# Ahsan Composite Ltd.

27 April 2014

# Observations

Structurally unsafe access ramp

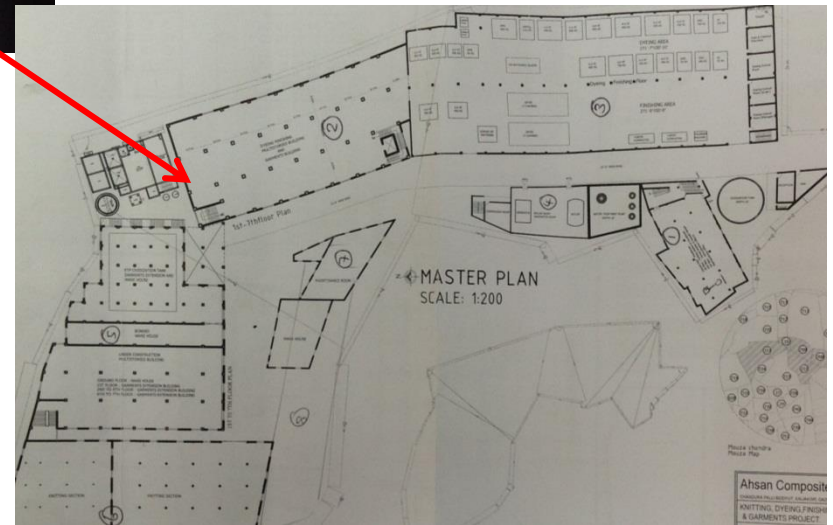
Access to mezzanine storage area is via a structurally unsafe timber ramp, loosely propped by bamboo.

**Columns standing in water**

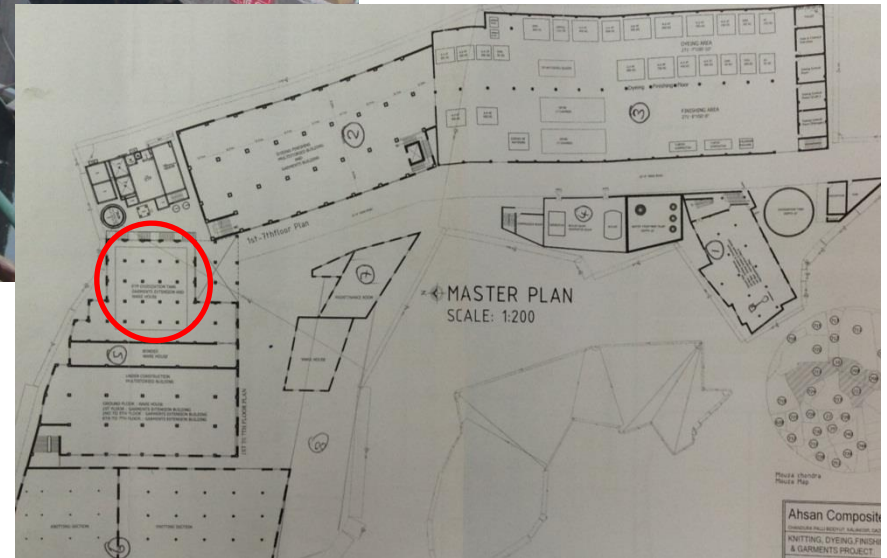
Ground floor columns are standing in reservoir. Depending on cover and cement content this could lead to corrosion and affect strength of columns.

Item No.	Observation	Recommended Action Plan	Recommended Timeline
40	Building 5 - Columns standing in water	Tests to be undertaken on liquid to assess if it is corrosive; if liquid is corrosive, detailed checks to be made on concrete for evidence of damage.	6-months
41	Building 5 - Columns standing in water	Detailed inspection to be made by Factory Engineer to check for evidence of spalling. Repeat annually.	6-months
42	Building 1 - Minor settlement cracking to facades	Factory Engineer to inspect annually to check for evidence of any ongoing movement.	6-months
